# Site Accessibility Evaluation

**Wheeler Ridge Park**  
**3100 Lipizzan Dr**  
**Denton, TX 76210**

**Accessibility Evaluation**

***Inspection Date: 04/14/2021***  
***Inspector: N/A***

### Barrier: 1

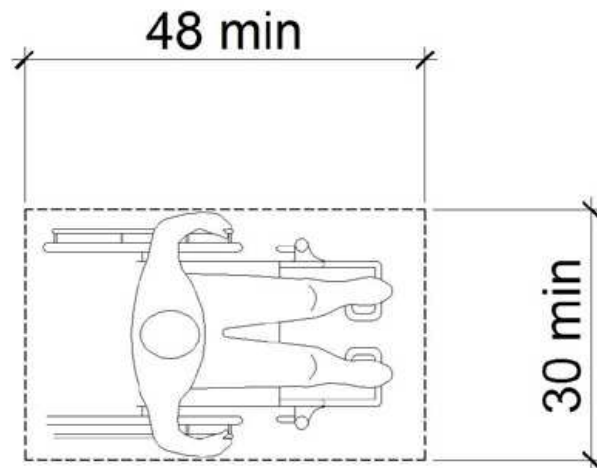
The clear floor space required at the bench is not flat (2 percent or 1:48 maximum slope) in all directions.

2010 ADAS Section: 305.2

The clear floor space required at the bench is not flat (2 percent or 1:48 maximum slope) in all directions.

Modify the clear floor space at the bench to provide a slope no greater than 2 percent in any direction.

### Barrier: 2

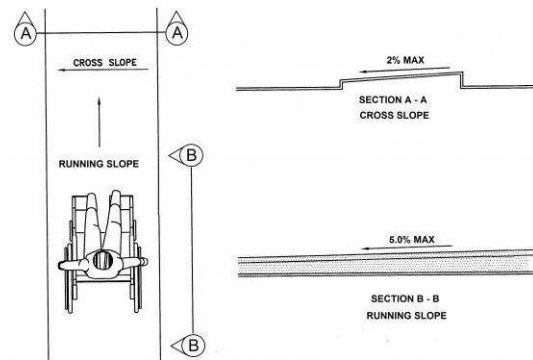
The accessible path of travel has cross slopes greater than 2 percent.

2010 ADAS Section: 403.3

The accessible route of travel contains a cross slope of 3 percent.

Modify path of travel to achieve a cross slope that is no greater than 1:48 (2.08 percent).

### Barrier: 3

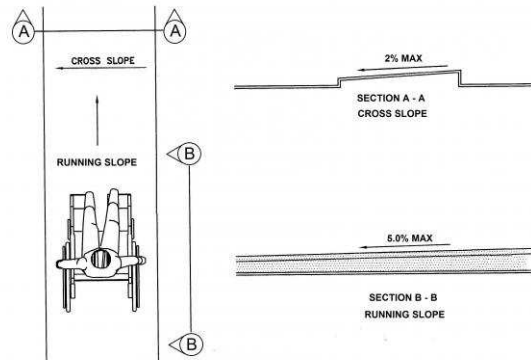
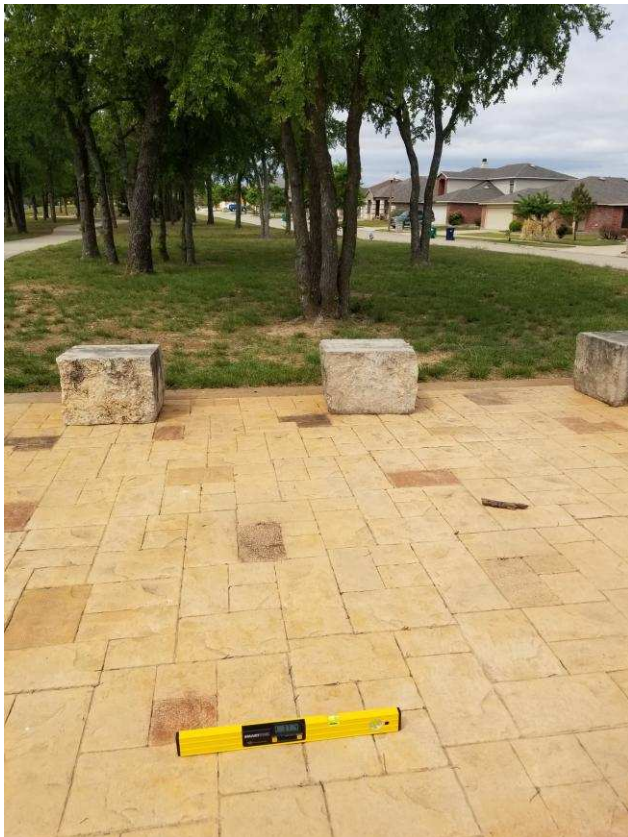
The accessible path of travel has cross slopes greater than 2 percent.

2010 ADAS Section: 403.3

The accessible route of travel contains a cross slope of 3.7 percent.

Modify path of travel to achieve a cross slope that is no greater than 1:48 (2.08 percent).

**Barrier: 4**

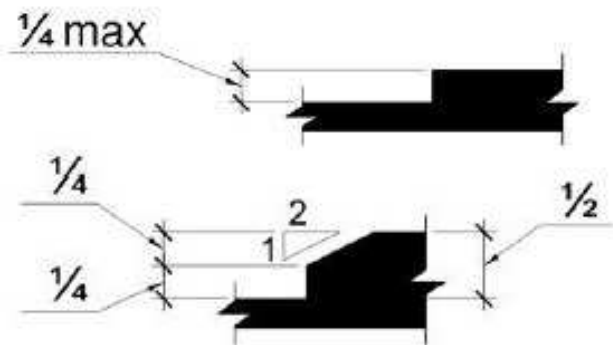
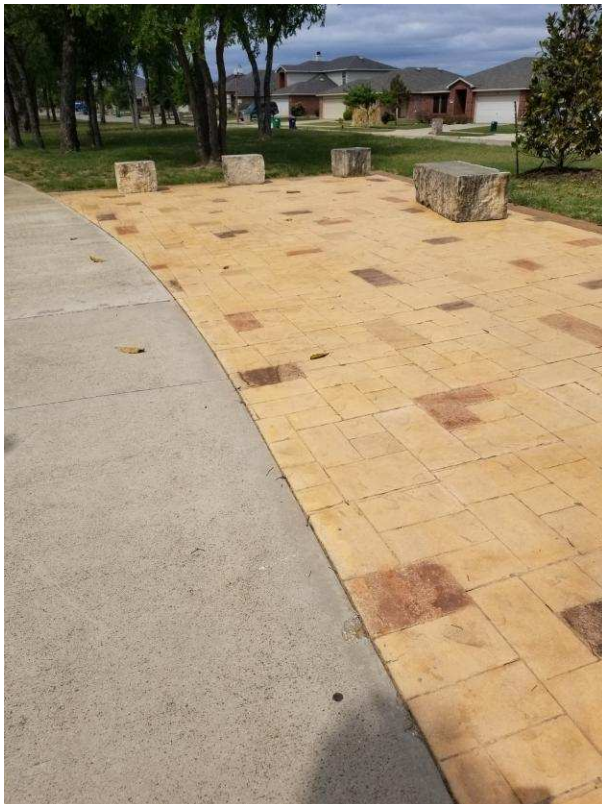
The walkway contains abrupt vertical edges and/or variations over 1/4 inch.

2010 ADAS Section: 303.3,  
303.2

The walkway contains  
abrupt vertical edges and/or  
variations over 1/4 inch

Modify the connection between the trail and seating area to provide a smooth level surface.

### Barrier: 5

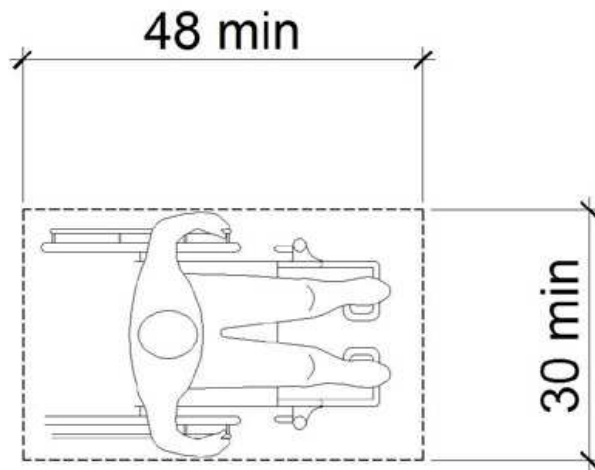
The clear floor space required at the bench is not flat (2 percent or 1:48 maximum slope) in all directions.

2010 ADAS Section: 305.2

The clear floor space required at the bench is not flat (2 percent or 1:48 maximum slope) in all directions.

Modify the clear floor space at the bench to provide a slope no greater than 2 percent in any direction.

**Barrier: 6**

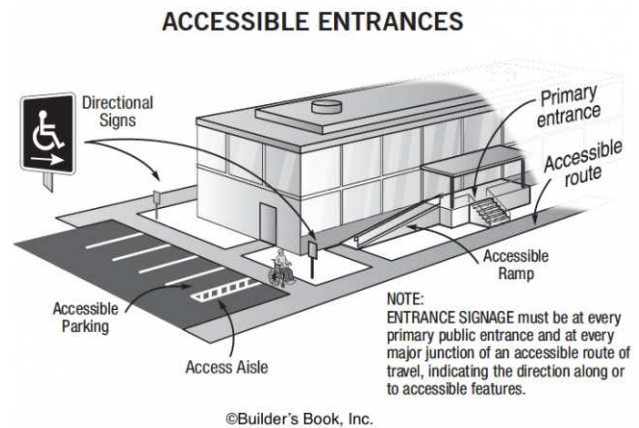
There is no accessible route to the dog waste dispenser.

2010 ADAS Section: 206.2.2

There is no accessible route to the dog waste dispenser.

Provide an accessible route to the dog waste dispenser.

### Barrier: 7

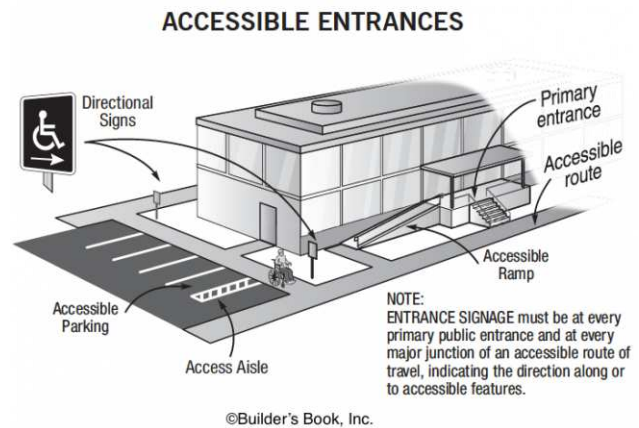
There is no accessible route to the dog waste dispenser.

2010 ADAS Section: 206.2.2

There is no accessible route  
to the dog waste dispenser.

Provide an accessible route of travel to the dog waste dispenser.
